Set #3.

One pair of identical gates (2 singles)

Dated Dec 29, 2025

Typ left gate viewed from property side

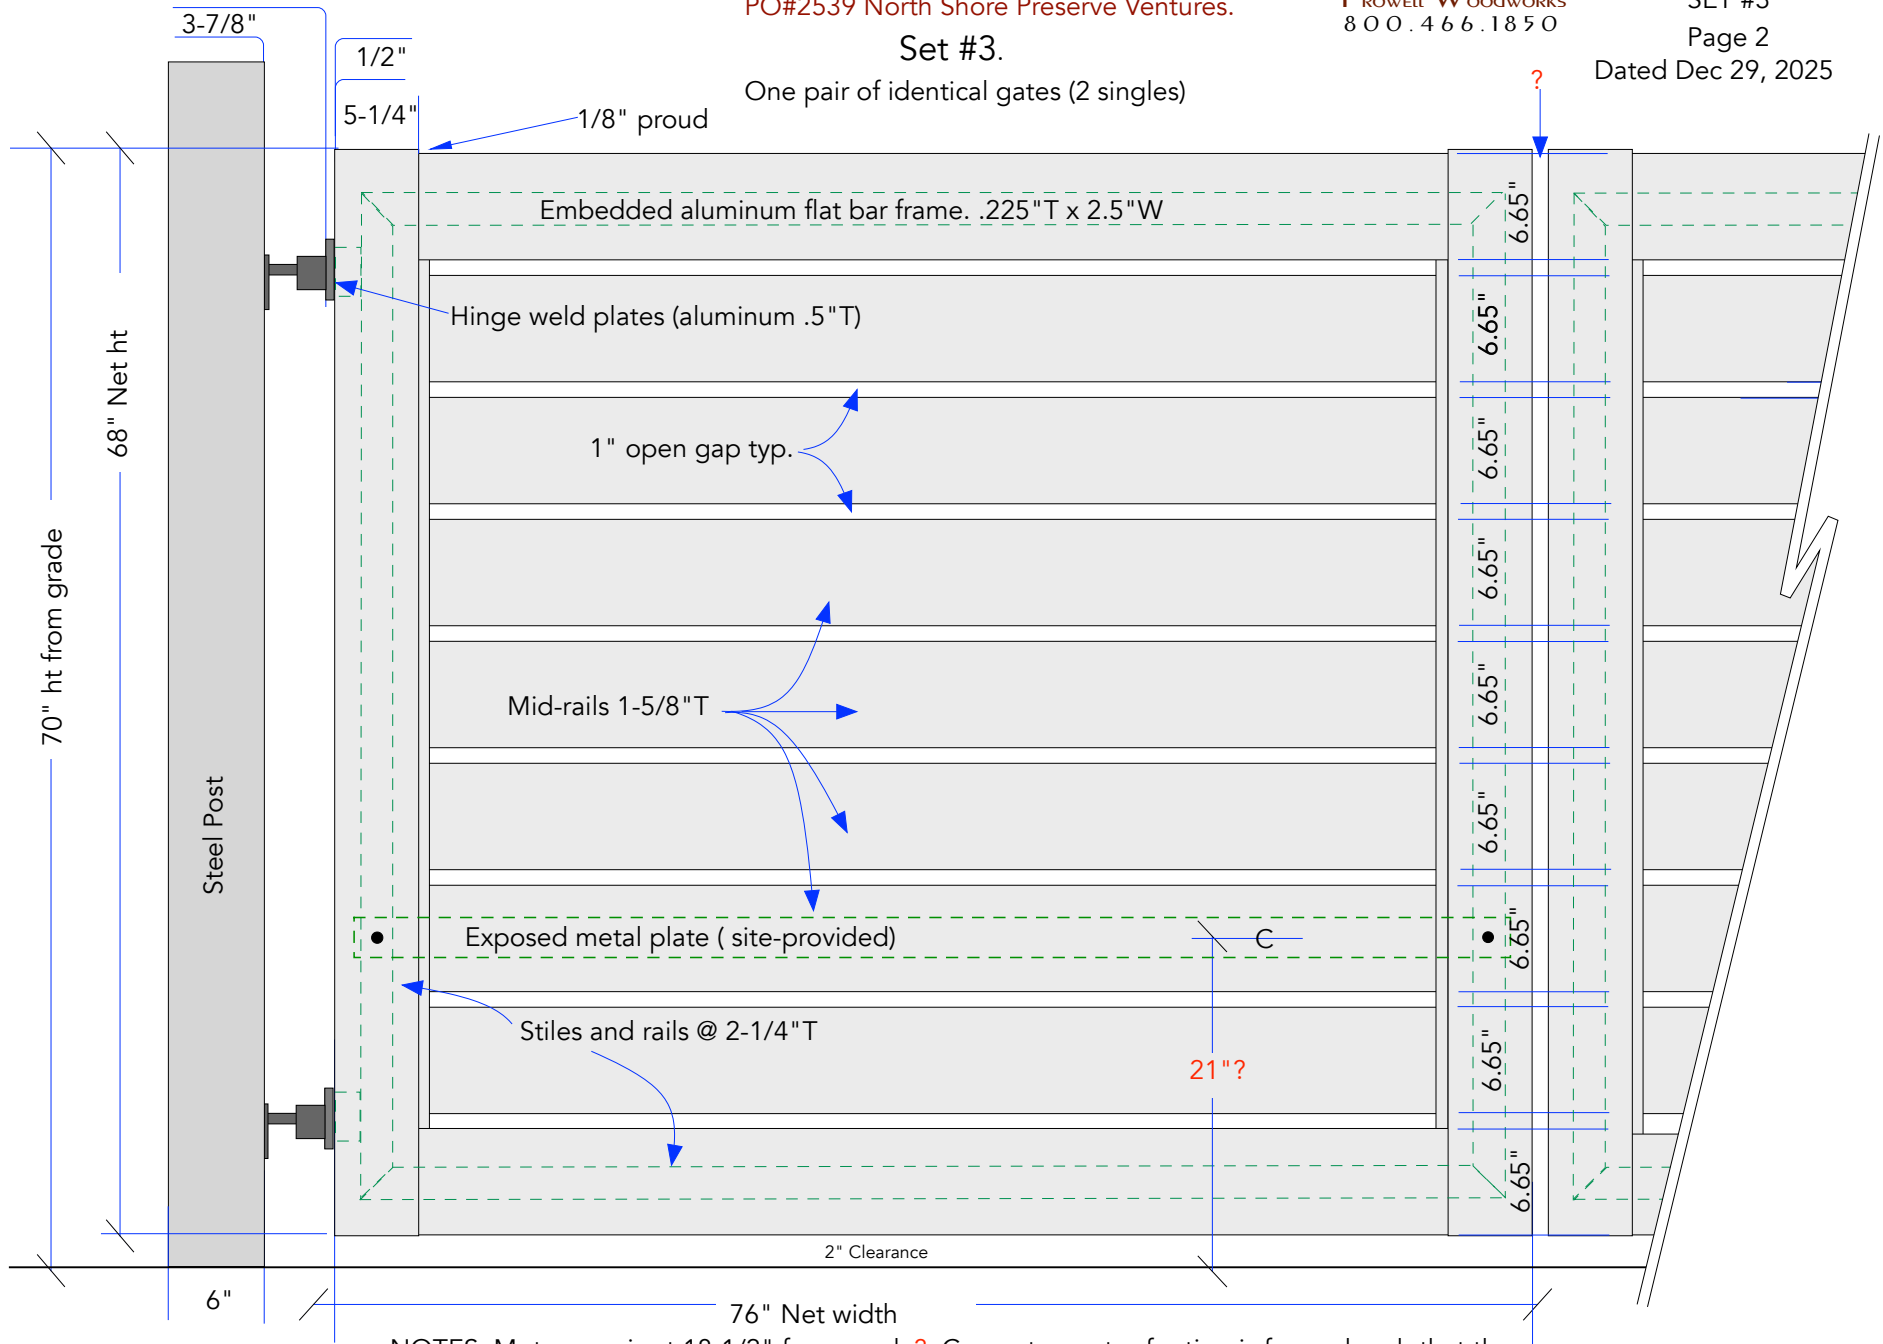
NOTES: Motor arm is at 18-1/2" from grade? Concrete motor footing is formed such that the motor arm mounts to the center of the 3rd rail from the bottom, at 21".(To be field verified)

* The height placement of the motor-arm mounting plate to be field verified.
